工程指示 / 要求簡箋(E.I.)

工程指示編號：EI/5400 / 22

工程名稱：將軍澳日出康城

工程項目：樣板層 T1 單元件 廠用玻璃 bm 改倉 (T1A/G+T1B/F) / (T1A/C+T1A/D) 32 件

# 58康城11期单元幕墙玻璃分层统计表 (T1 单元幕墙)

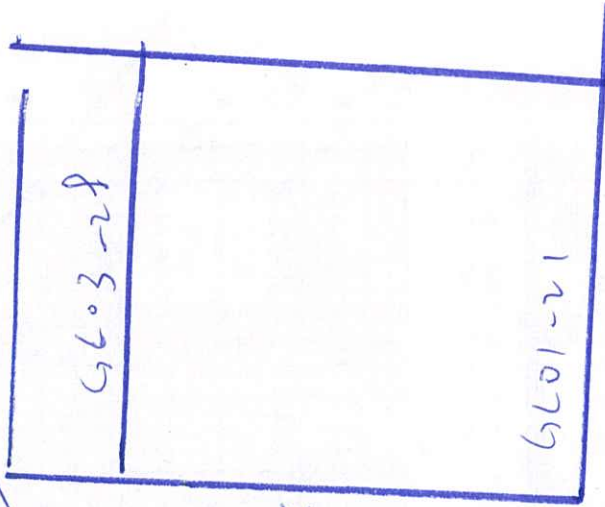
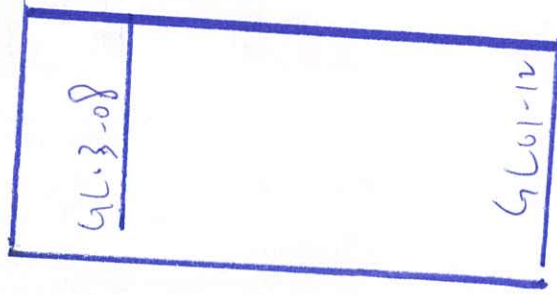
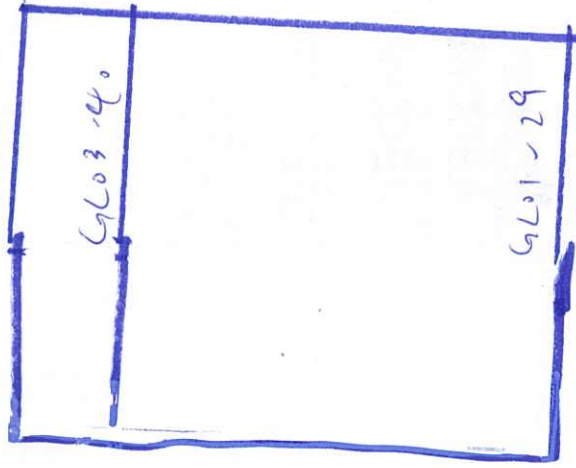
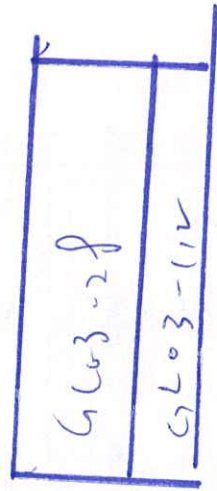
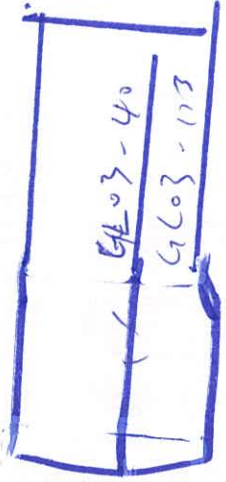
玻璃  
编号  
如上  
FG  
或CD尾  
以免混乱

16 件單元 - 32 件玻璃

12 件起腳 - 12, 15, 16 件

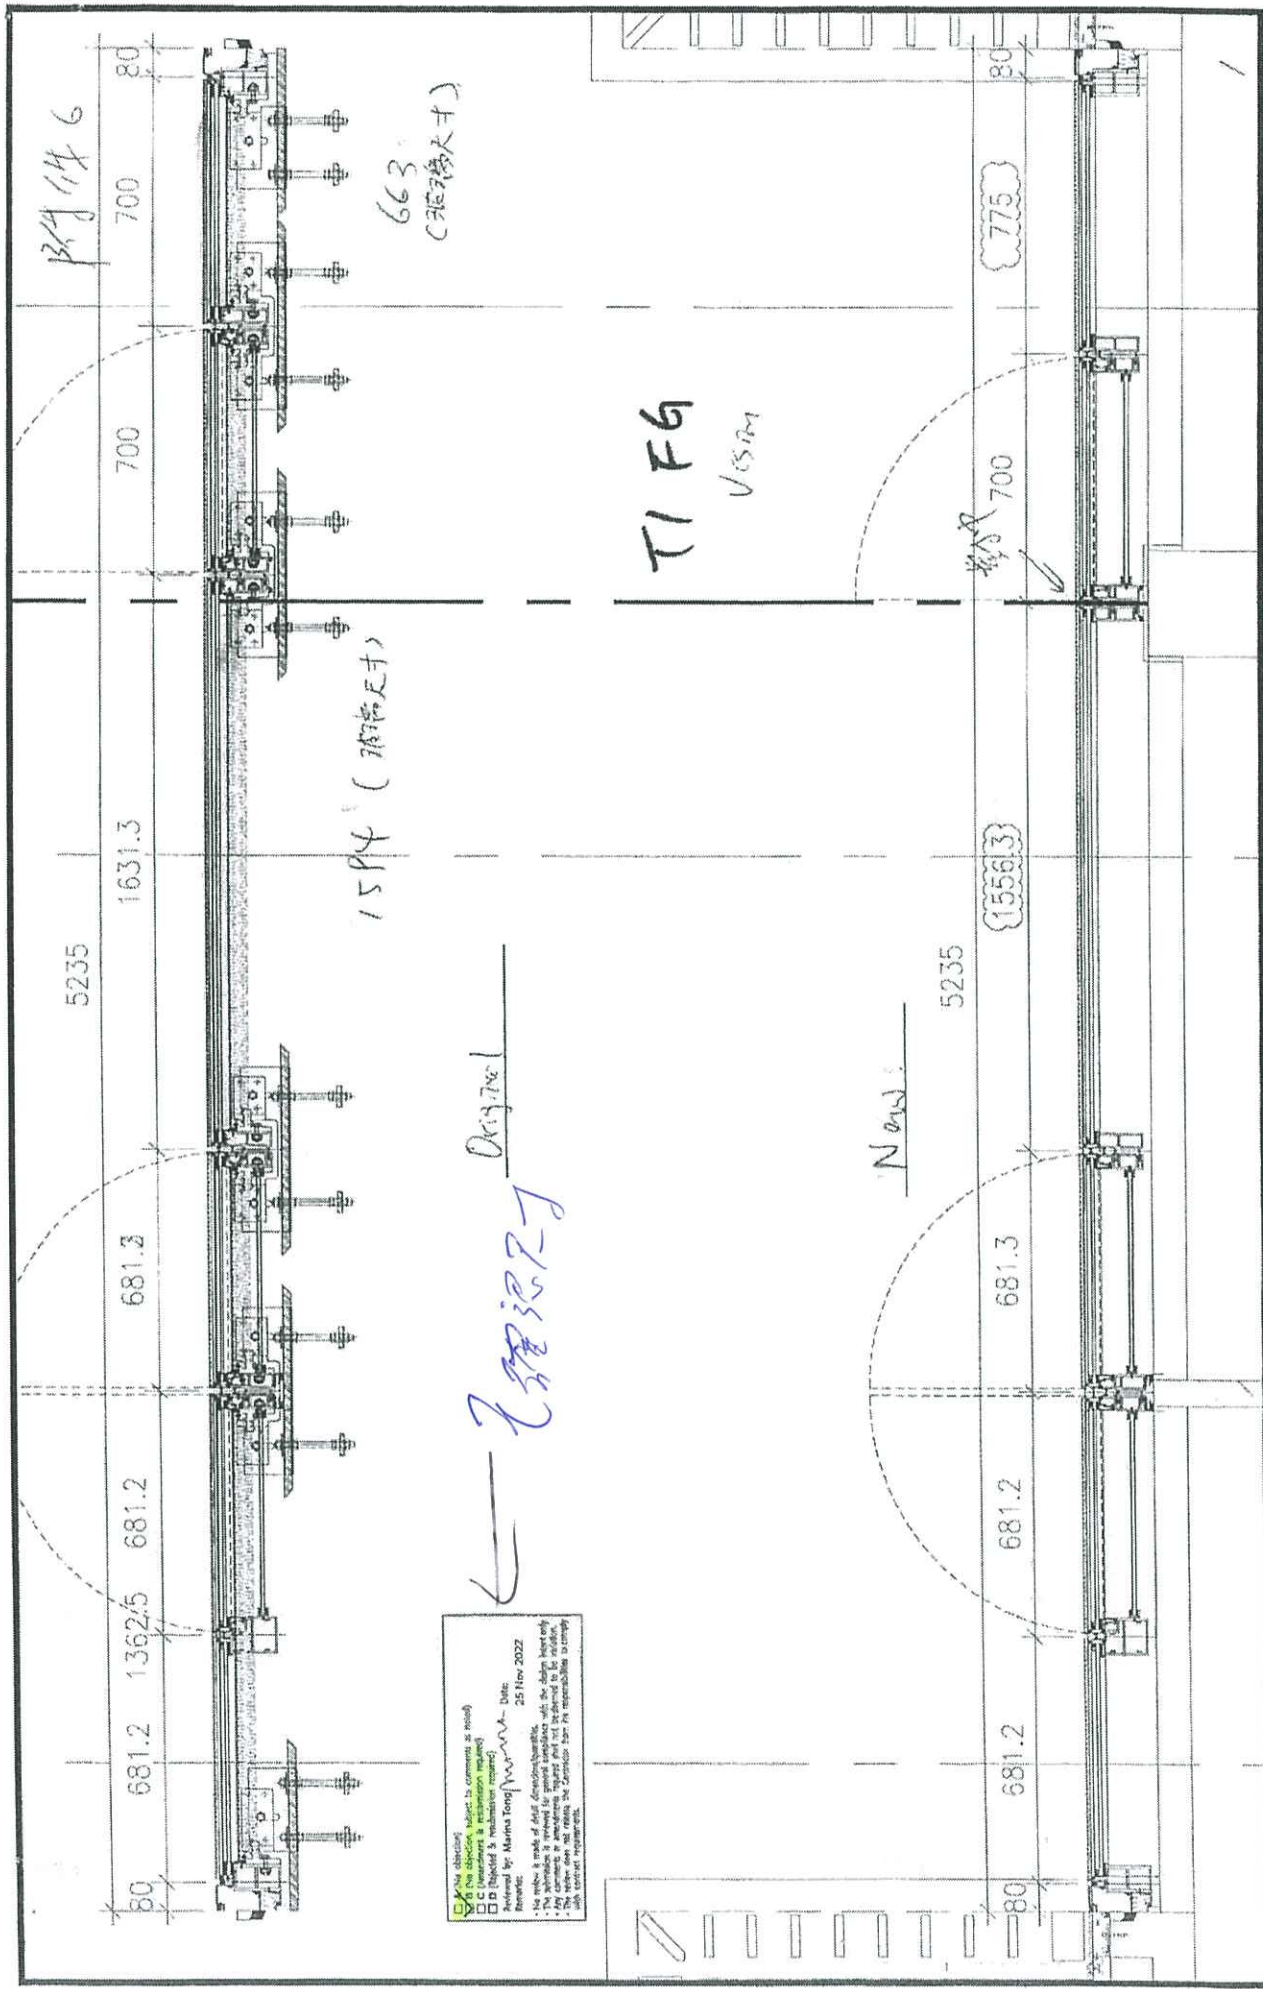
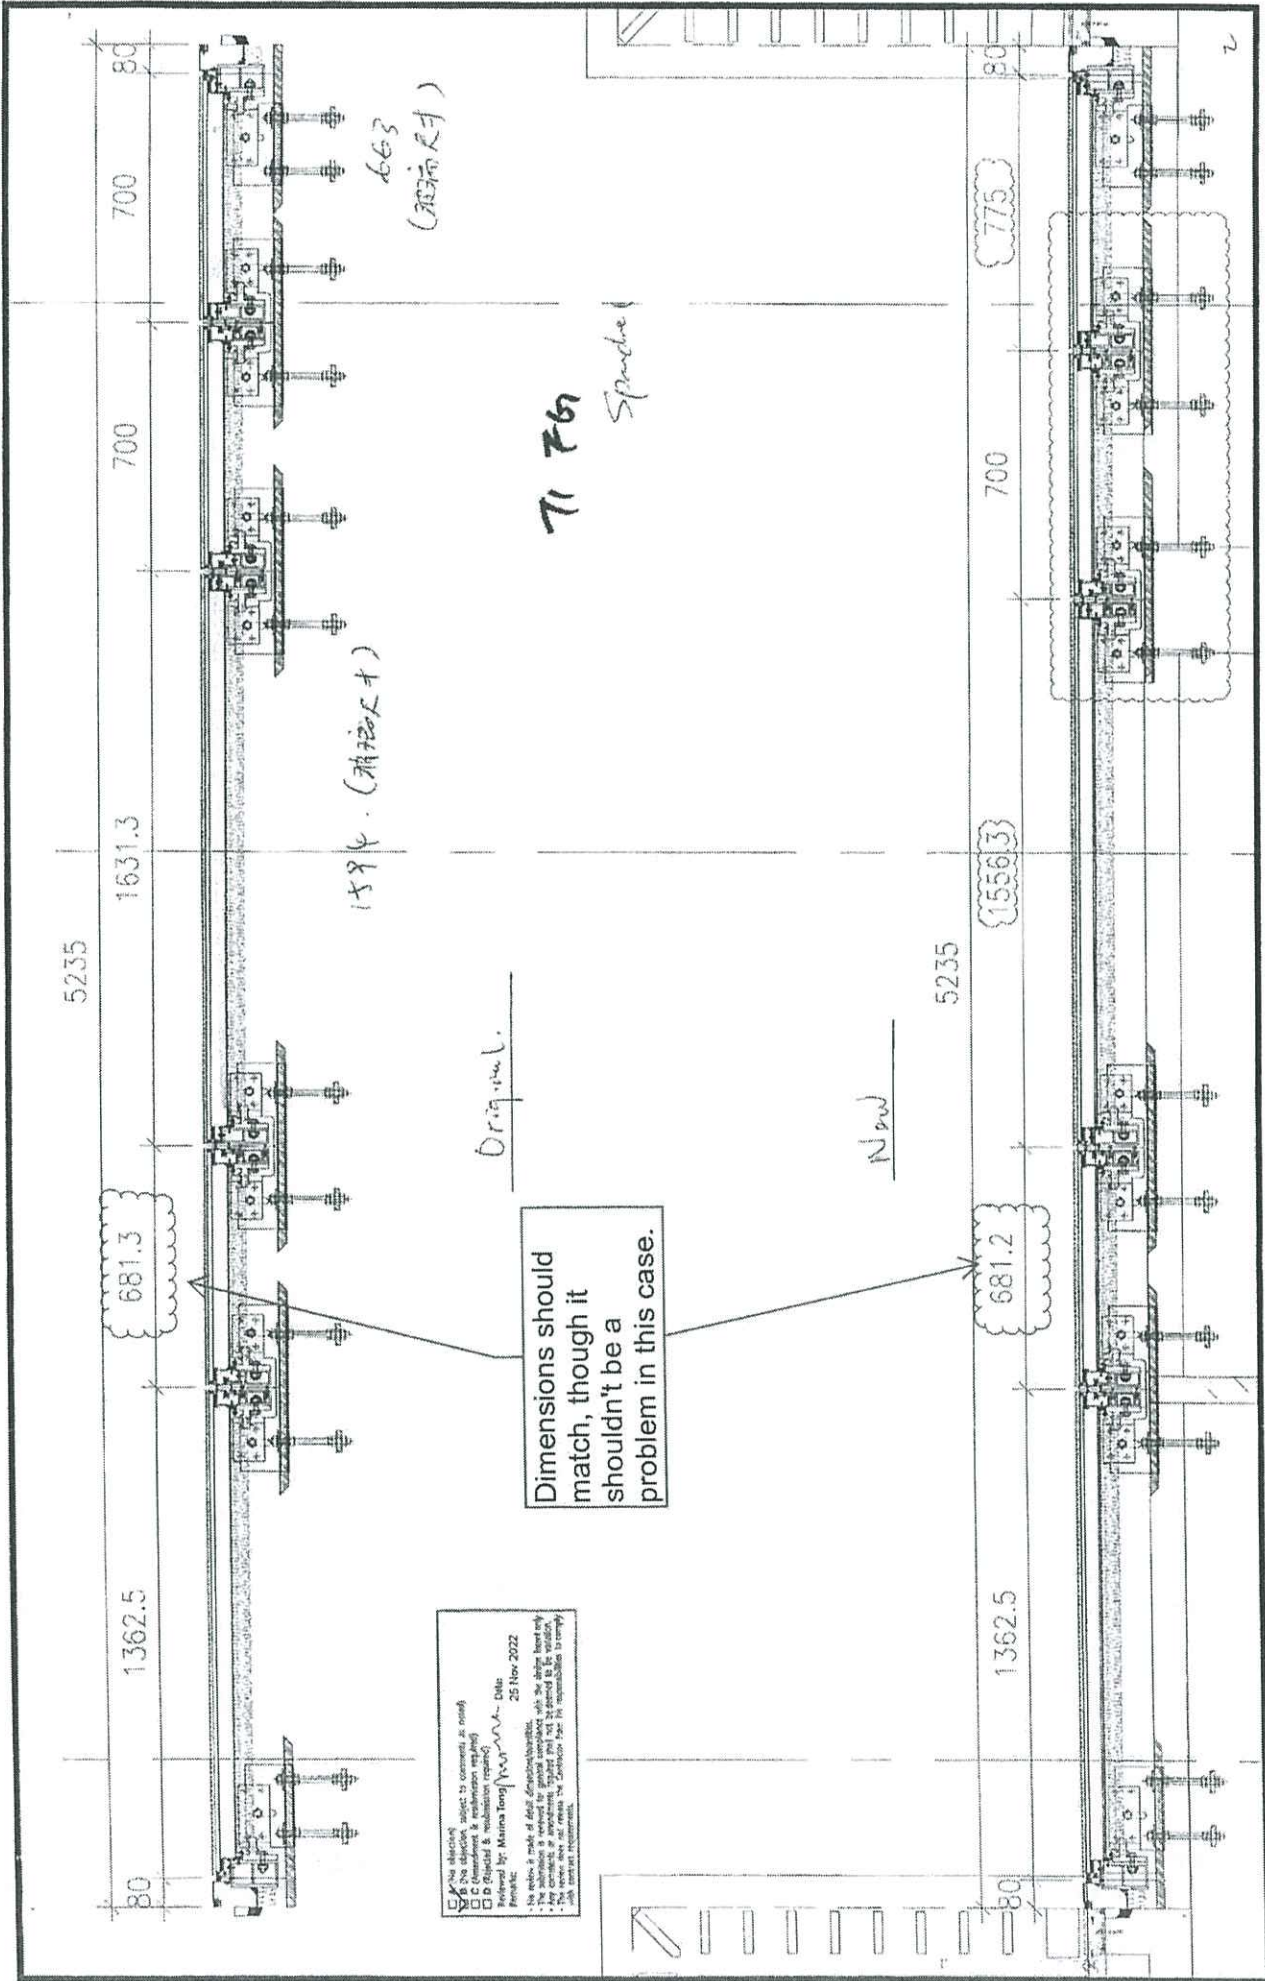
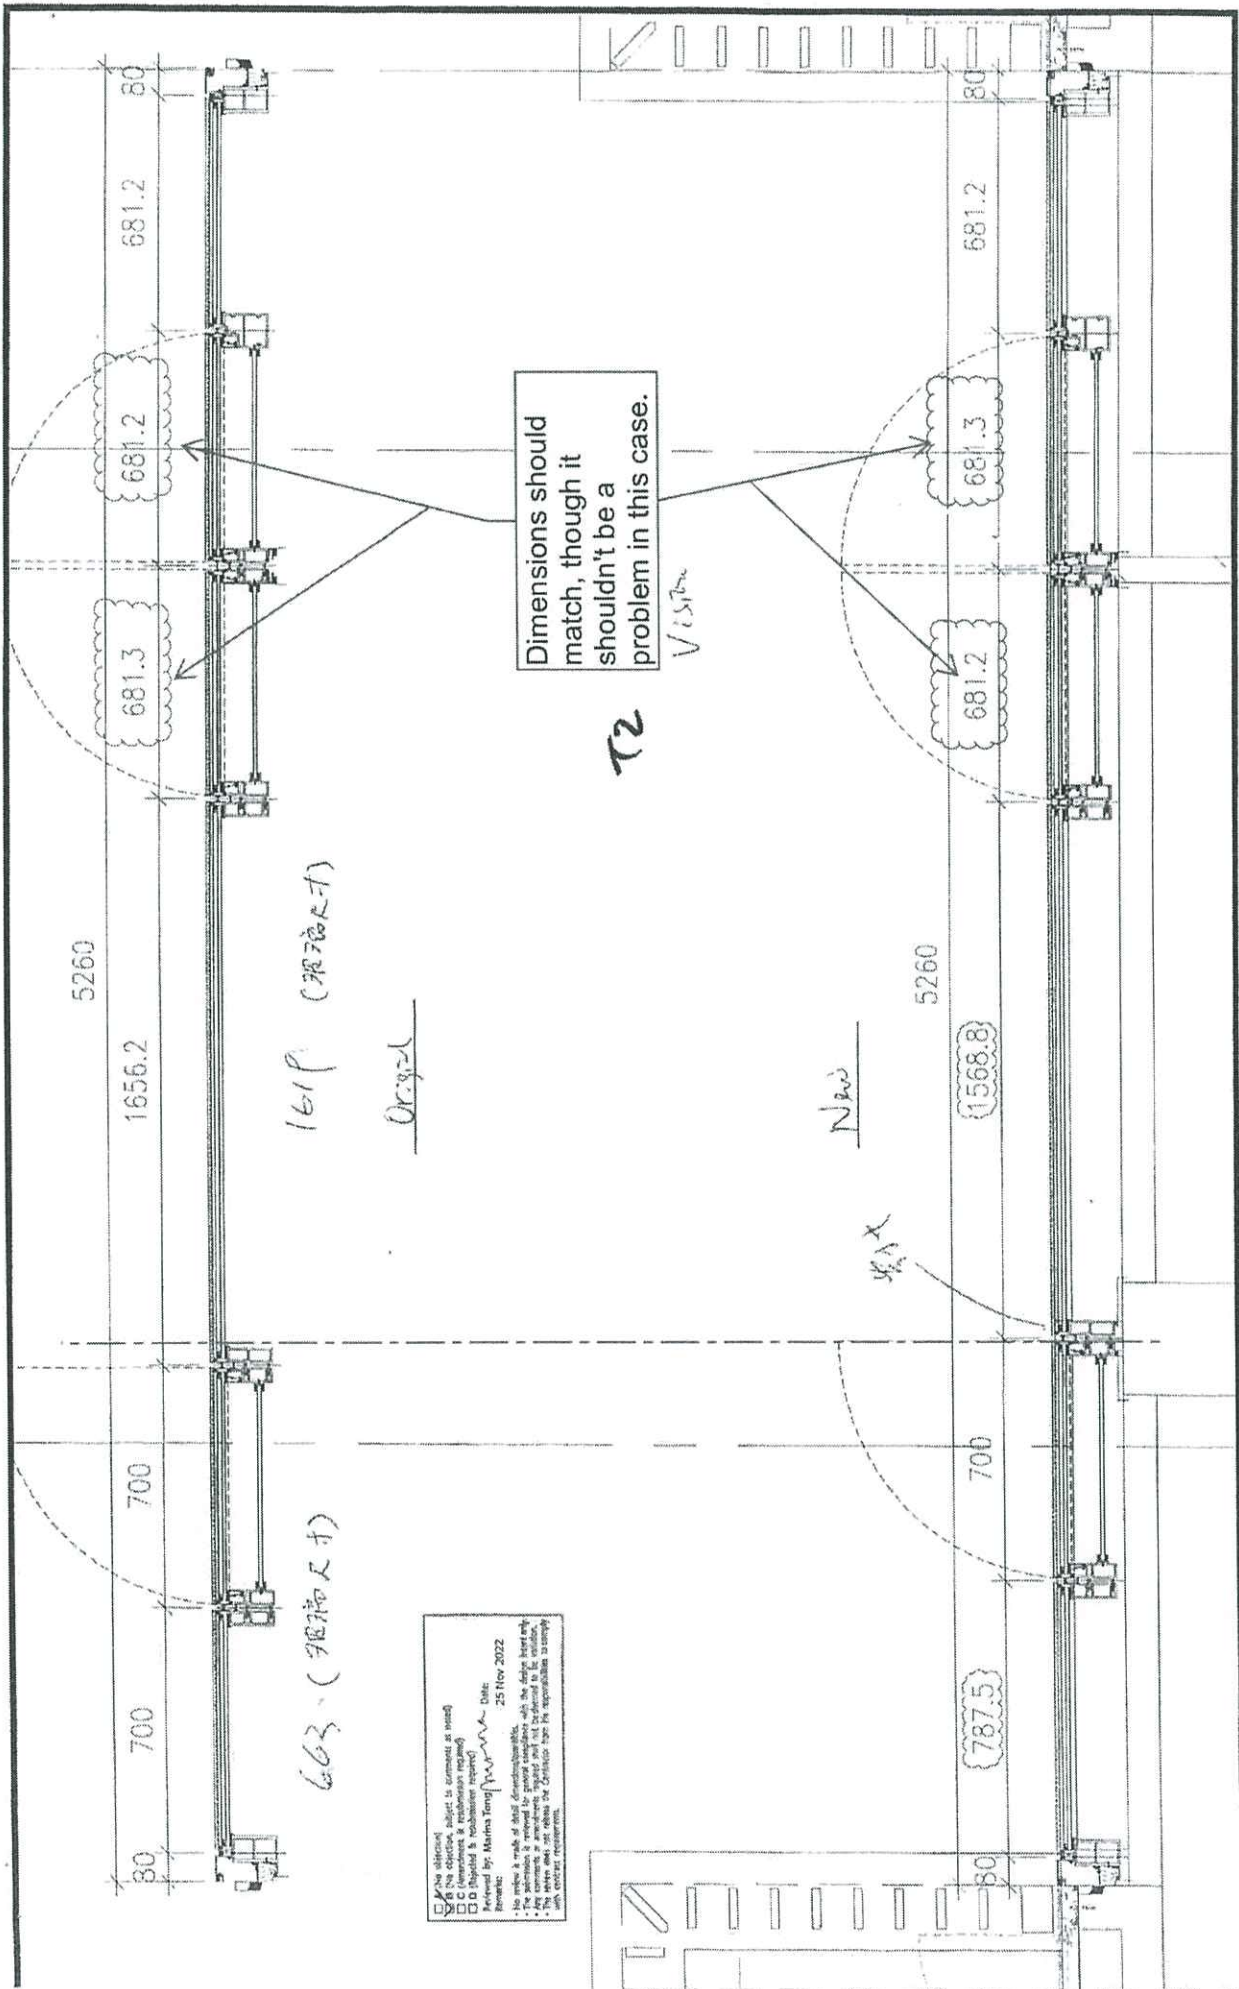
現回覆Lohas P11 - Rectification of Curtain Wall Window Division between 2 Flats  
(二零二二年十一月二十一日)

本公司已按Comment 修改和批圖生產, 現修改將涉及 Abortive materials and works。和涉及額外時間重新生產。如需確認進行更改, 請發出A.I 確認。

附件6，為修改後尺寸。如需改動，請發出 A.I 確認修改後尺寸。

Please find our reply to your Appendix 6 at the link below for your further action:

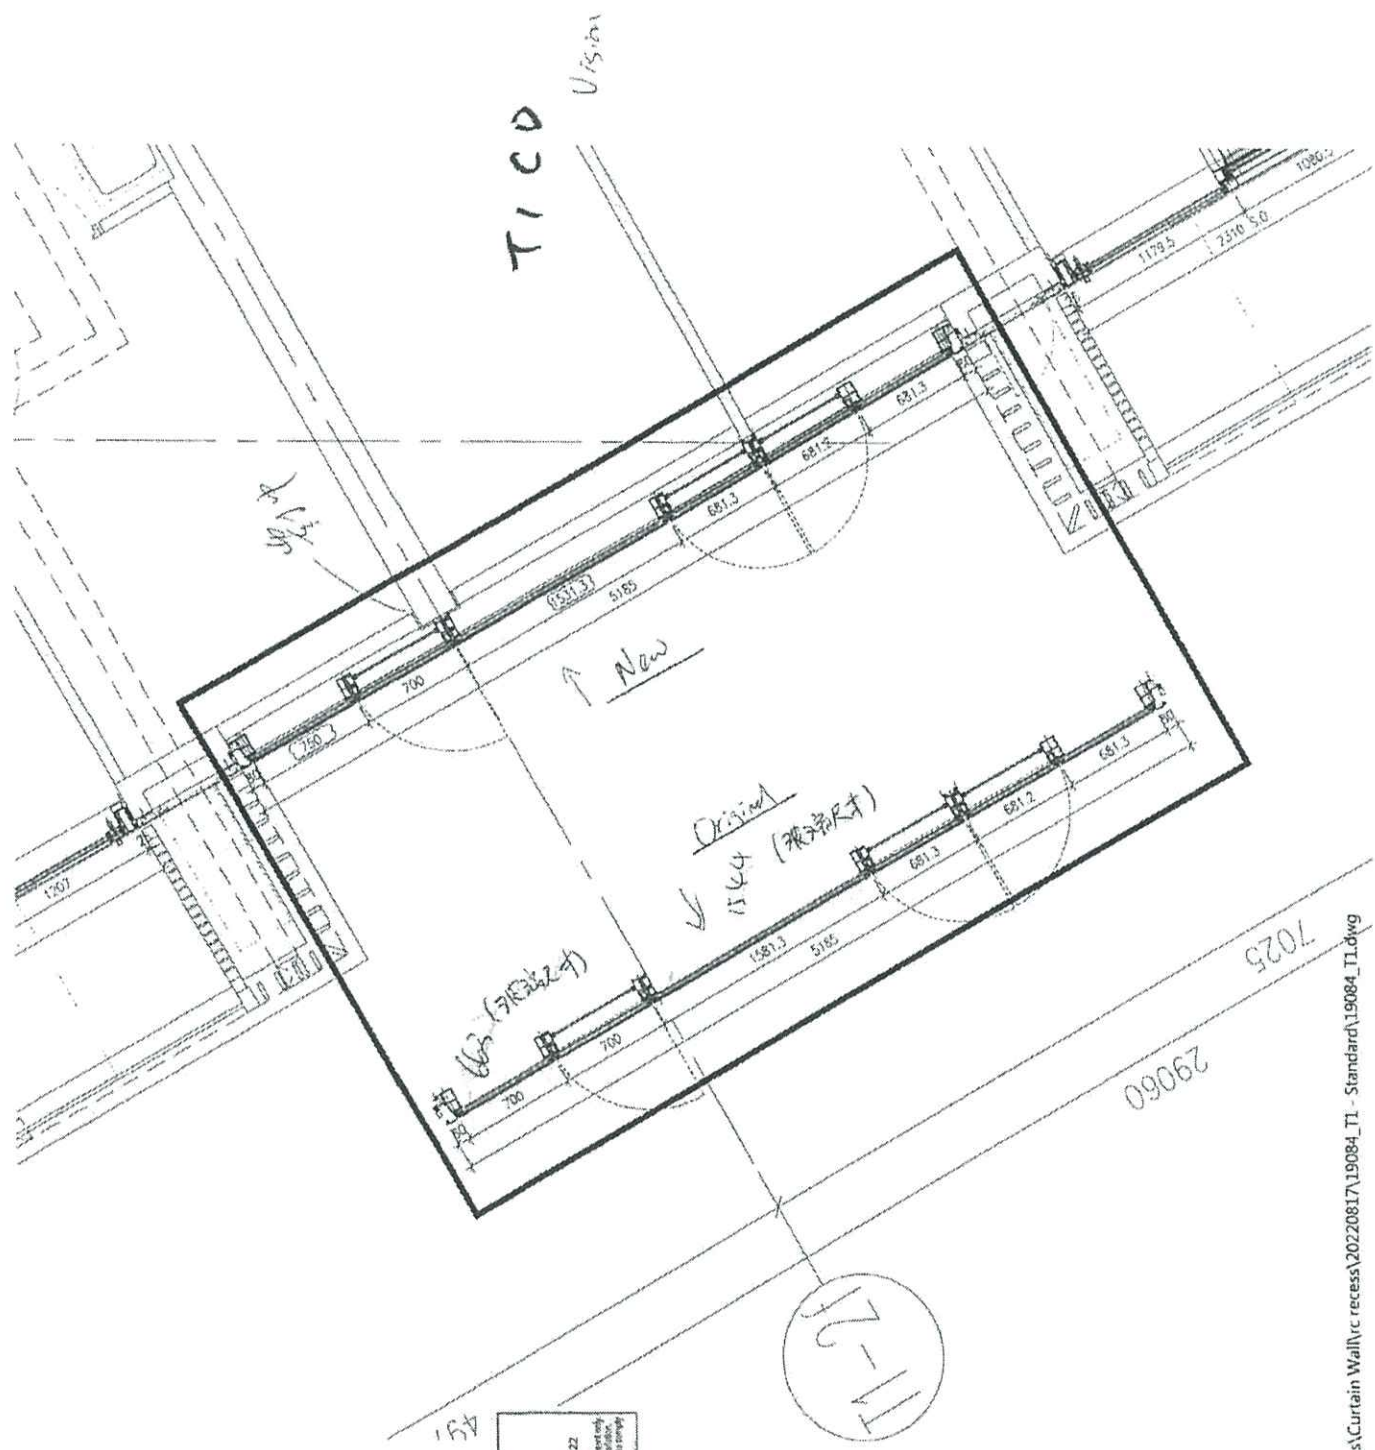
Dimensions should match, though it shouldn't be a problem in this case.
